MODIFICATION OF CONSENT REPORT 061/07DA (S96028/16) – PROPOSED MODIFICATION OF CONSENT OF SUBDIVISION OF 1 LOT INTO 7, LOT 21 DP 1094386 - MAGPIE HOLLOW ROAD SOUTH BOWENFELS NSW 2790

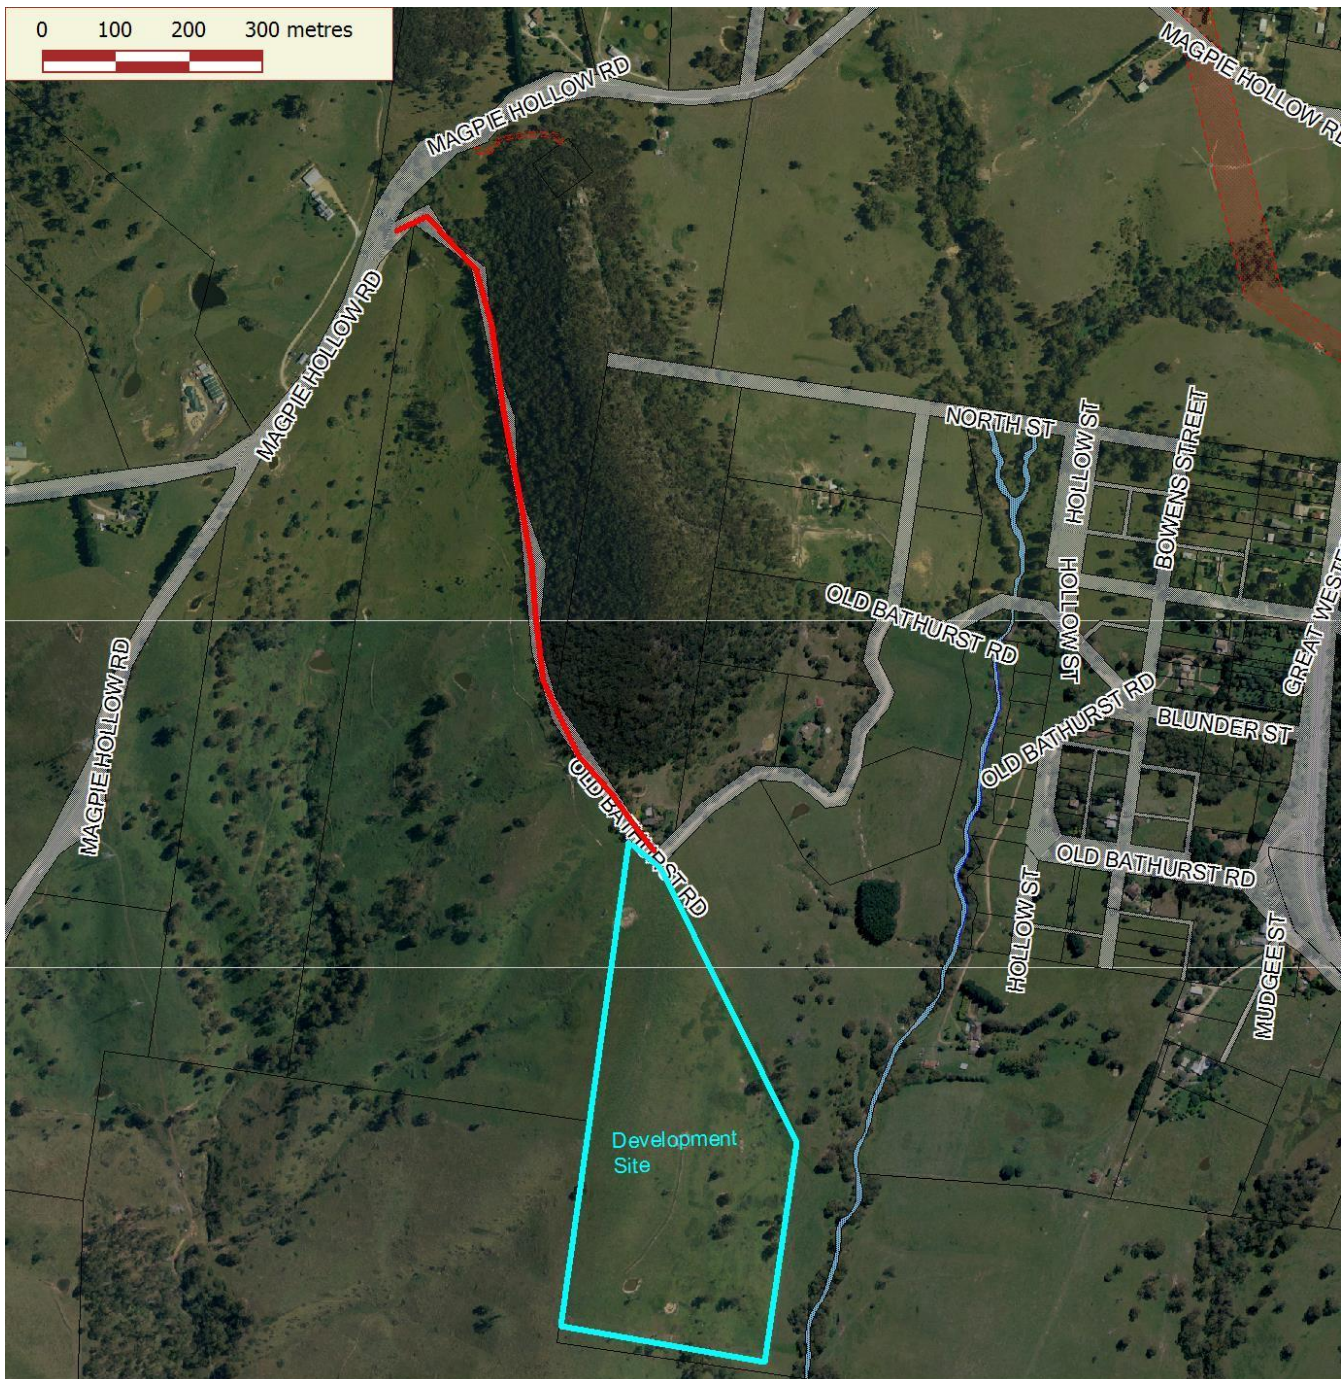
Section 94 Contributions for Rural Roads was assessed as part of the original approval in 2008 through conditions of consent as below:

53 *A contribution of \$21,000 (7*\$3000) being \$3,000 per new allotment is to be paid towards the upgrading of roads to be paid prior to the issue of the Subdivision Certificate, in accordance with Council's adopted Section 94 Contribution Plan for rural roads.*

The total contributions levied for 061/07DA was to be \$21,000.00 under Lithgow City Council Rural Roads Section 94 Contribution Plan 1998. It is requested that Council remove the condition as a result of the proposal by the applicant to seal Old Bathurst Road from Magpie Hollow Road to the new road as part of the subdivision. The sealed section is approximately 1 km in length as per map below and Council Engineers estimate the cost at over \$60,000.00.

The cost of sealing this section of Council maintained road is almost three times the amount of contributions that would have been received as part of the rural roads contributions. Sealing of this road means less ongoing maintenance is required by Council and is beneficial to the surrounding area.

In conclusion, Council receives a financial benefit from the removal of the consent condition 53 as a section of Old Bathurst Road will be sealed at a value in excess of \$60,000.

- 53 **The applicant is to commit to the sealing of Old Bathurst Road from Magpie Hollow Road to the intersection of the new road of the subdivision prior to Subdivision Certificate release.** ~~A contribution of \$21,000 (7*\$3000) being \$3,000 per new allotment is to be paid towards the upgrading of roads to be paid prior to the issue of the Subdivision Certificate, in accordance with Council's adopted Section 94 Contribution Plan for rural roads.~~
